Advanced Response to

Request for Additional Information No. 525(6194, 6154)

U.S. EPR Standard Design Certification

SRP Section: 09.01.04 - Light Load Handling System (Related to Refueling)

Figure 09.01.04-30-1
Spent Fuel Cask Transfer Machine- Main Structural Assemblies

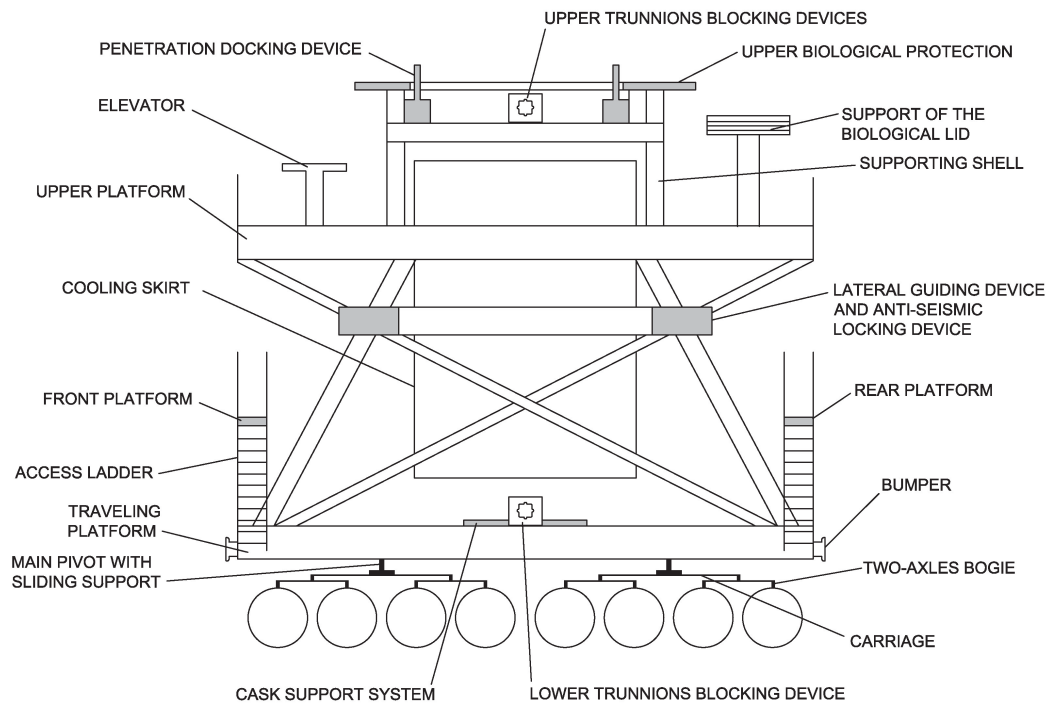
Question 09.01.04-30:**OPEN ITEM**

As shown in Figure 09.01.04-30-1 □ Spent Fuel Cask Transfer Machine-Main Structural Assemblies, and as described below, the SFCTM has three main structural assemblies:

Figure 09.01.04-30 will be added as a new figure to U.S EPR FSAR Tier 2, Section 9.1.4.2.2 as U.S. EPR FSAR Tier 2, Figure 9.1.4-13 □ Spent Fuel Cask Transfer Machine-Main Structural Assemblies.
